RESPONSE TO REQUEST FOR ADDITIONAL INFORMATION

APR1400 Design Certification

Docket No. 52-046

RAI No.: 415-8503

Figure 15.06.05-15-1 CEFLASH-4AS Inner Vessel Phase Separation Model.

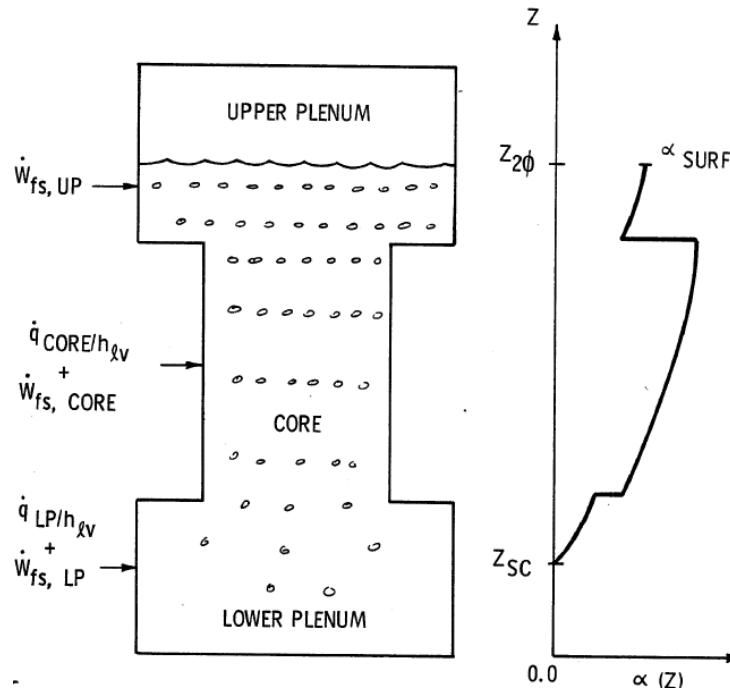
Please explain how the two-phase water level in the core was determined. The applicant needs to provide a clear definition of the two-phase level, and elaborate on any criteria or thresholds involved. Document the assumptions involved in calculating the two-phase water level in the core, and justify combining CEFLASH-4AS and COMPERC-II reflood two-phase levels as a conservative approach. Provide a plot of CEFLASH-4AS and COMPERC-II two-phase levels for a cold leg break which requires an extended period of interpolation between CEFLASH-4AS and COMPERC-II. Identify the time period when interpolation between the CEFLASH-4AS and COMPERC-II 2-phase levels is occurring, and explain what are the two endpoints of the interpolation that are being used to get the final two-phase level

In CENPD-137 (page 30~42) the two-phase mixture level is explained in detail. This response is written to summarize the explanation provided in CENPD-137. The total node mixture level is determined using the phase separation model (see Figure 15.06.05-15-1) and the bubble rise model as described below. The bubble rise model in CEFLASH-4AS has been modified to more realistically describe the effects of non-uniform bubble distribution within a node. CEFLASH-4AS computes the dynamic bubble mass from the following expression:

The bubble population distribution using these assumptions is shown in the Figure 15.06.05-15-1.

Figure 15.06.05-17-1. Influence of ECC Injection Model on Annulus Pressure Transient

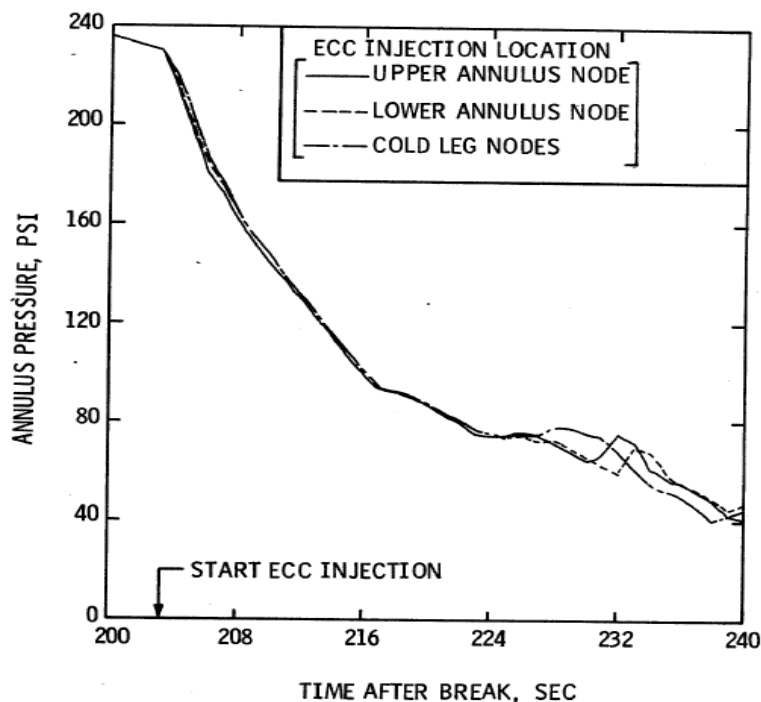
CEFLASH-4AS node diagram in Figure 3.1-1 of the SBLOCA Technical Report (APR1400-F-ANR-14001-P) indicates that the safety injection tank (SIT) and safety injection pump (SIP) flows are injected into the downcomer below the node where the cold legs are connected to the downcomer. The TeR description of Figure 3.1-1 also mentions that the emergency core cooling system (ECCS) is modeled by flow paths connected to the lower annulus. However, the direct vessel injection (DVI) nozzles are actually located in the upper annulus of the APR1400 design, 2.1 m above the cold leg nozzles. Therefore, this simulated arrangement may lead to a non-conservative retention of water in the reactor pressure vessel (RPV) by reducing the amount of ECC bypass. The approved CE-ABB SBLOCA methodology specifies that CEFASH-4AS is to be used until the SITs are activated. Thus, for smaller breaks in the cold leg, there is ample opportunity for the pumped safety injection to be bypassed to the break, an effect which is precluded with the nodalization being employed in the CEFASH-4AS model. It appears that the applicant's depicted methodology provides no mechanism for the ECCS injection water to be ejected out of the break, and thus, may be non-conservative in this regard. Please demonstrate that placing the DVI nozzles in the lower annulus instead of the upper annulus, where they are physically located, results in a conservative or realistic treatment of ECCS injection in the CEFASH-4AS simulations for both the DVI line and cold leg breaks. Also describe where the DVI line break and cold leg break nodes are located in the CEFASH-4AS model.

According to the CENPD-137(page 119), a sensitivity study for the three injection locations(upper annulus, lower annulus, and cold leg) was performed in order to determine the influence of injection location in CEFASH-4AS on the calculated annulus pressure

transient. The sensitivity study shows that the pressure transient used for reflood calculations is insensitive to the CEFLASH-4AS ECC injection location (See figure 15.06.05-17-1).
